## Oil Injection Crankcase Pressure Valve – 135 thru 275

### Mariner and Mercury

135-200 S/N OD067952 and above

275 S/N OD070440 XL and above  
S/N OD078274 CXL and above  
S/N OD078285 XXL and above

51379

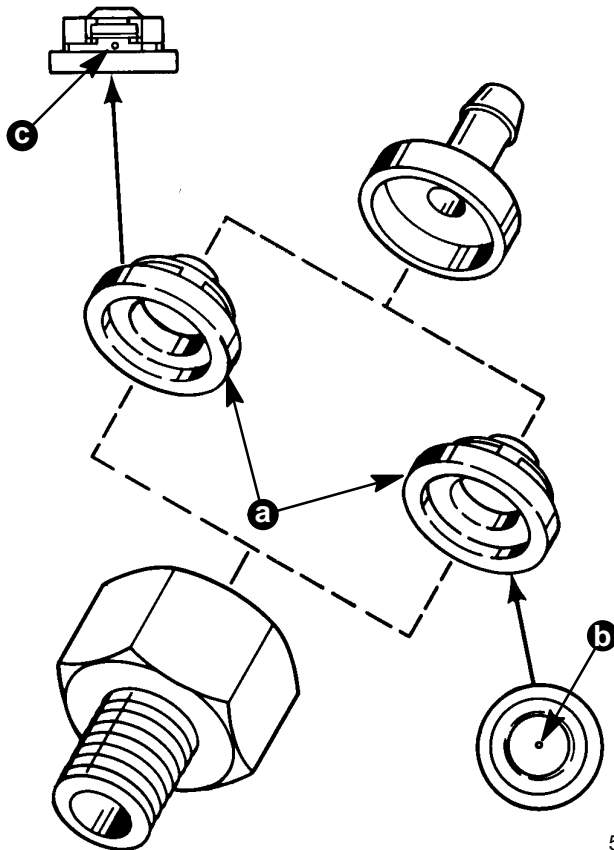
There has been a product improvement to the crankcase pressure valve P/N 21-43278. The valves used before the serial number listed above had 0.0135 in. (0.34mm) pressure relief hole in the center of disc in the inner check valve. The new valve will have the hole moved to the side of the inner check valve to lessen the possibility of blockage and ease of manufacturing.

- a - Inner Check Valve
- b - Previous Pressure Relief Hole
- c - New Pressure Relief Hole

When inspecting the previous style check valve, the pressure relief hole can be seen from either end. The new valve does not have an external hole that can be seen. To determine that the pressure relief hole is open on the new valve, slowly loosen the filler cap on remote oil tank one minute after engine shut down. There should not be any pressure released.
